PUBLIC HEARING MEMORANDUM

SUBJECT: **Petition #70-20** for a SPECIAL PERMIT/SITE PLAN APPROVAL to amend Council Order #106-07 to allow a full time nursery school, to allow parking within a setback, and to reduce the minimum open space at **349 Dedham Street** on land known as Section 83 Block 36A, Lot 01, containing approximately 33,697 square feet of land in a district zoned Single Residence 1. Ref: Sec. §3.1.6, §5.1.8.A.1, §5.1.13, §7.3.3, and §7.4, of the City of Newton Revised Zoning Ord, 2017.

349 Dedham Street

Proposed Site Plan

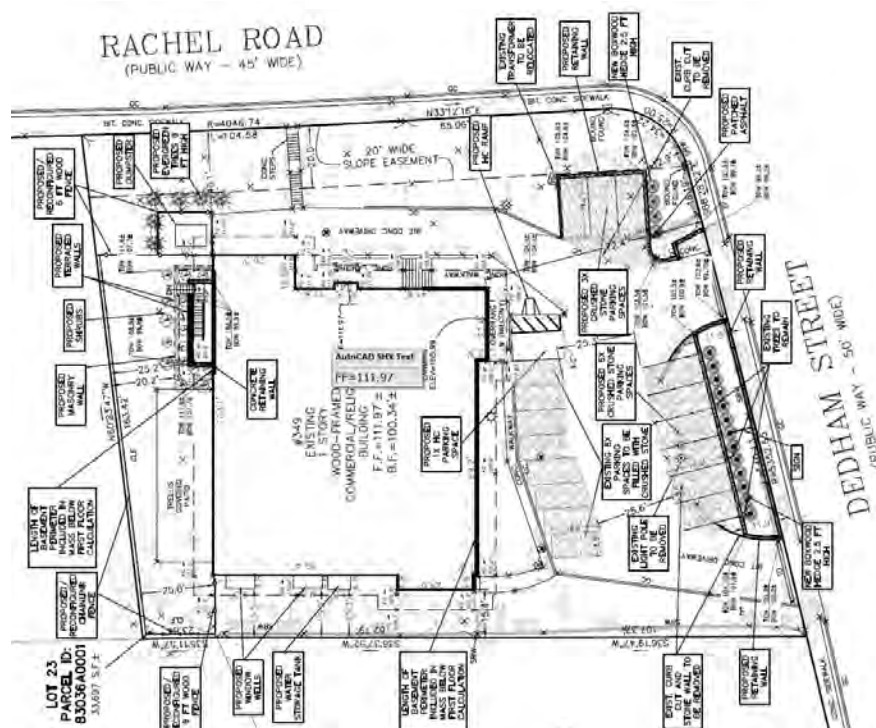
The petitioner is proposing to construct nine parking stalls within the setback distances of Dedham Street and Rachel Road. Constructing these stalls will require the loss of landscaping in both locations and will require adjustments to the retaining walls within the Dedham Street setback and new retaining walls within the Rachel Road setback. These walls are less than four feet in height and therefore do not require relief. The additional parking stalls decrease the amount of open space on the lot to 42.9%, where 50% is the minimum allowed, requiring a waiver from the Commissioner of Inspectional Services or a variance from the Zoning Board of Appeals. The petitioner is proposing to screen the parking stalls within the Dedham Street setback in the form of existing landscaping and proposed boxwood plantings, but the stalls within the Rachel Road setback are not screened. Staff suggests that boxwoods or similar plantings be installed to screen these stalls given that they will be more visible due to their elevation above Rachel Road. Nevertheless, it appears that proposed screening may not meet the standards required by the Ordinance and staff suggests that the petitioner consider meeting those standards. Otherwise, additional relief is required or a waiver via the Dover Amendment must be obtained.

The plans also indicate that a light pole will be removed to allow for the stalls within the Dedham Street setback, but its new location is not shown on the plan. Staff suggests that the petitioner confirm whether this pole will be installed elsewhere on site because the petitioner received a waiver from the lighting requirements. The plans also indicate that a water tank is proposed at the eastern side of the structure. The Planning Department suggests that the petitioner provide more information on this tank because of its location within the setback.
